# Technical Service Bulletin

**01 MIL on, DTC P218100, P017B00, P308100, and/or P01E400 are stored in the ECM**

01 20 65 2058767/5 June 8, 2020. Supersedes Technical Service Bulletin Group 01 number 20-63 dated May 18, 2020 for reasons listed below.

*Figure 1. Gap between chamber and seal.*

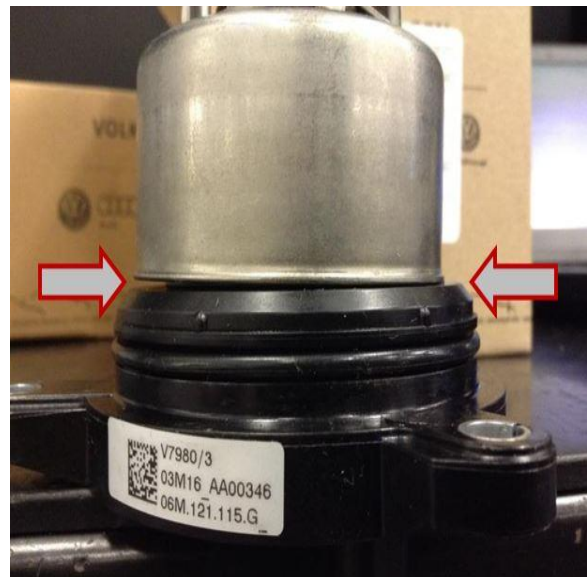
1. Remove the thermostat and check whether it closes completely. If the coolant is still warm, put the thermostat in cold water to restore its original condition. If there is a gap between chamber and seal, the thermostat is faulty and needs to be replaced.
2. Attach photos to the repair order which clearly shows that the thermostat does not close neatly.

After the repair, fill with G12evo coolant in the coolant circuit.
